104th session

Regulation No. 110 (Specific equipment for CNG)

Proposal for amendments to Regulation No. 110 (Specific equipment for CNG and/or LNG)

Submitted by the Chair of the Task Force on Liquefied Natural Gas vehicles*

Figure 1-1

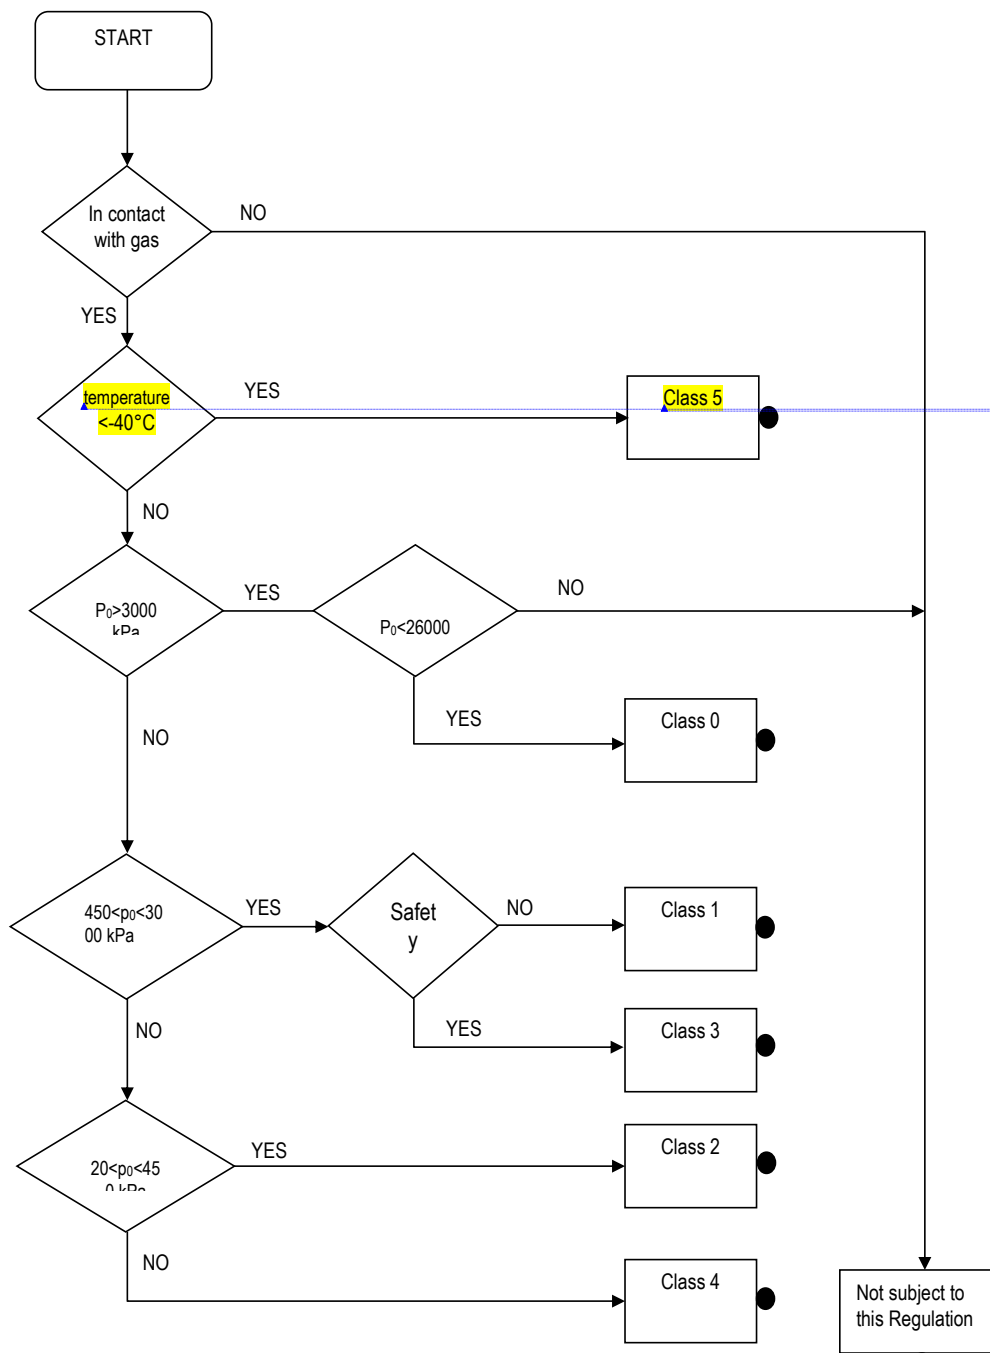
Comment [DP7]: Reason for making a separate chapter 3 for classification of components is for readability of the document.

Figure 1
20 MPa filling unit (receptacle) for M₁ and N₁ vehicles

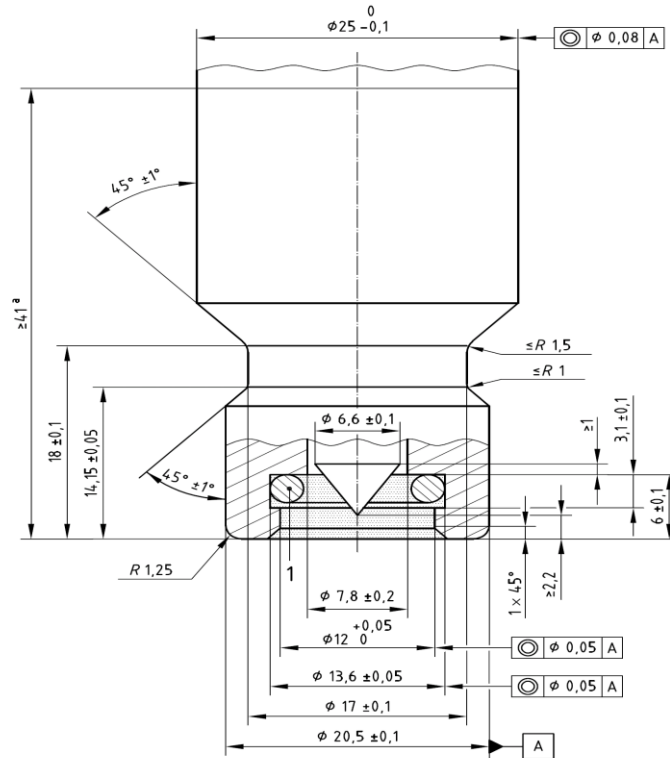
of this regulation. In this case, dimension 25 +0/-1 becomes 24 +0/-1 in Figure 1 and 35 +0/-1 becomes 34+0/-1 in Figure 2.

Comment [A57]: After checking with Paul, we don't know why this is not included in the last official version sent by Romain, so we decided to include it here. We should confirm with Romain if it was deleted on purpose or not
